<b>AMENDMENT OF SOLICITATION/MODIFICATION OF CONTRACT</b>				1. CONTRACT ID CODE <b>J</b>	PAGE OF PAGES <b>1   6</b>
2. AMENDMENT/MODIFICATION NO. <b>0003</b>		3. EFFECTIVE DATE <b>16-Aug-2010</b>	4. REQUISITION/PURCHASE REQ. NO.		5. PROJECT NO. (If applicable)

14. DESCRIPTION OF AMENDMENT/MODIFICATION (Organized by UCF section headings, including solicitation/contract subject matter where feasible.)  Design/Bid/Build services w hole center repairs for the Naval Operation Service Center (NOSC) located in Roanoke, Virginia.  The purpose of this amendment is to provide responses to project related bid inquires.  All other terms and conditions remain unchanged.					
Except as provided herein, all terms and conditions of the document referenced in Item 9A or 10A, as heretofore changed, remains unchanged and in full force and effect.					
15A. NAME AND TITLE OF SIGNER (Type or print)			16A. NAME AND TITLE OF CONTRACTING OFFICER (Type or print)		
			TEL:	EMAIL:	
15B. CONTRACTOR/OFFEROR		15C. DATE SIGNED	16B. UNITED STATES OF AMERICA		16C. DATE SIGNED
(Signature of person authorized to sign)			BY _____		16-Aug-2010
			(Signature of Contracting Officer)

**TITLE:** Design/Bid/Build servic

**METAL EDGING DETAIL AT LOBBY 100, CORRIDOR 116C AND 116D**

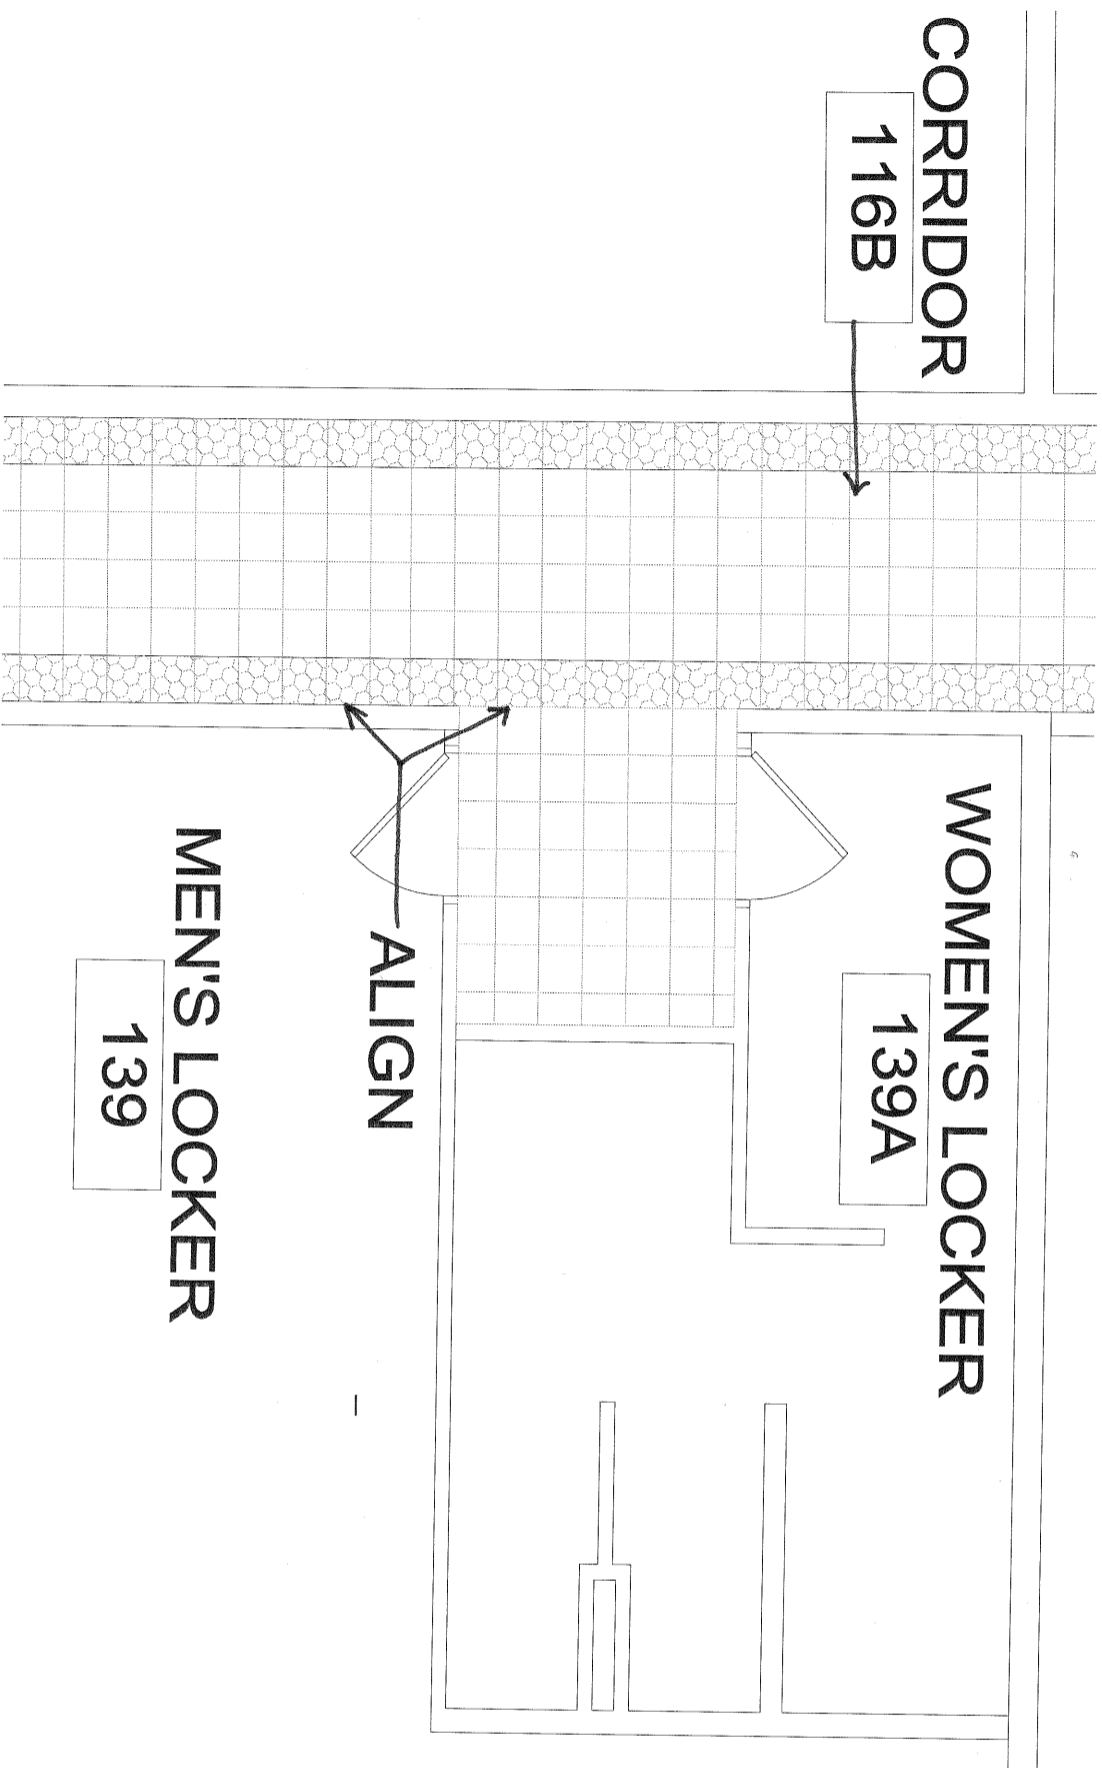
Please provide a detail for the metal threshold transition similar to the location indicated on Detail 1 on Sheet IN-101 for the transition between VCT and terrazzo tiles

See Attachment A-Bid Inquiry 2\_Question 7.

1. PROVIDE METAL EDGING DETAIL AT LOBBY AREA WHERE FLOOR TRANSITIONS BETWEEN TERRAZZO TILE AND VINYL COMPOSITION TILE (VCT).
